Replace 85A.8 with the following:

85A.8 Channel integrated crosstalk noise (ICN)

Figure 85A–1 — Channel integrated crosstalk noise

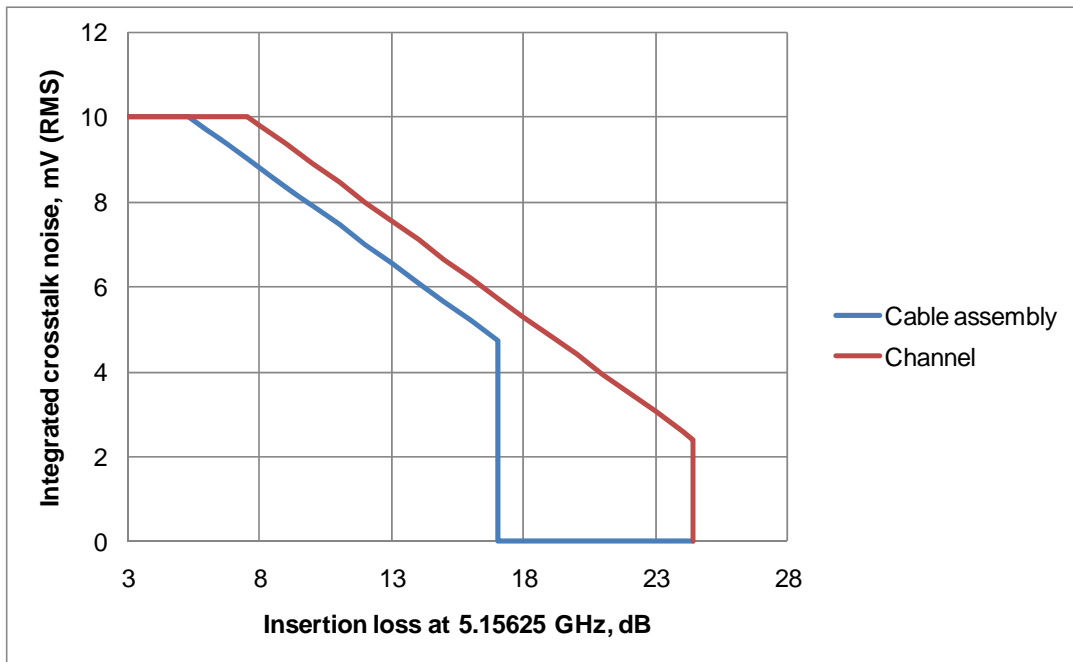
Given the channel insertion loss at 5.15625 GHz, IL , the total integrated crosstalk RMS noise voltage is recommended to be less than the value specified by Equation (85A–6) illustrated in Figure 85A–1.

$$\sigma_{x,ch} \leq \begin{cases} 10 & 3 \leq IL \leq 7.5 \\ 13.4 - 0.45 IL & 7.5 \leq IL \leq 24.44 \end{cases} \quad (85A-6)$$
